APPLICATION NO.	FILING DATE	FIRST NAMED INVENTOR	ATTORNEY DOCKET NO.	CONFIRMATION NO.
10/679,421	10/07/2003	Michio Masuda	TOC-0008	3476

Office Action Summary

MASUDA, MICHIO

DETAILED ACTION

KOBUSCH Fig 5

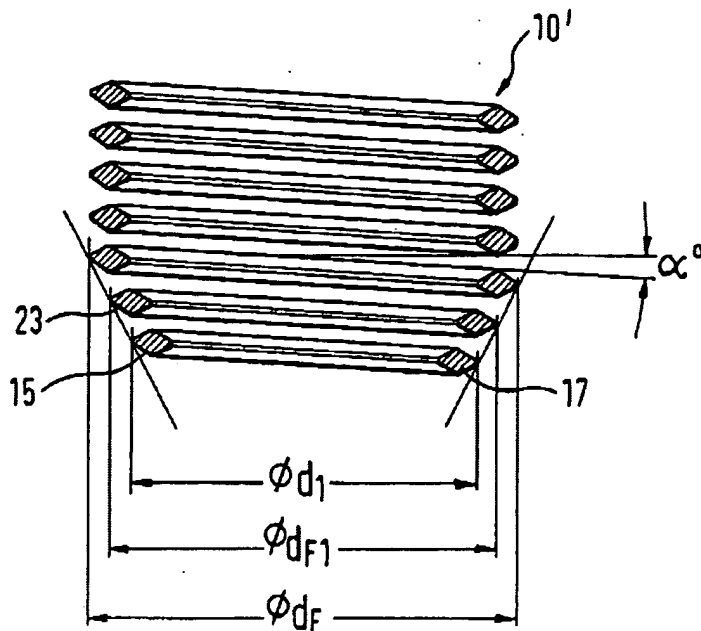
Kobusch teaches a spiral coil shaped insertion body formed by coiling a rhombic cross-section wire (Fig 2 or 5) and capable of insertion into a female screw and capable of receiving a male screw, the spiral body comprising:

- a cylinder portion of fixed diameter (straight portion formed by top 5 threads above)
- a tapered portion with outside diameter reduced from cylinder portion toward distal end of spiral body (tapered portion formed by bottom 3 threads above)
- the outside thread pitch diameter of cylinder section $>$ pitch diameter of the female screw (col 3 lines 1-12, col 4 lines 7-19)
- the inside thread pitch diameter of a region of the taper portion covering 1 or more turns $<$ pitch diameter of a male screw. There is a male screw that is usable with the coil which has a pitch diameter larger than the inside thread pitch diameter of the taper portion. No male screw limitation is positively recited.
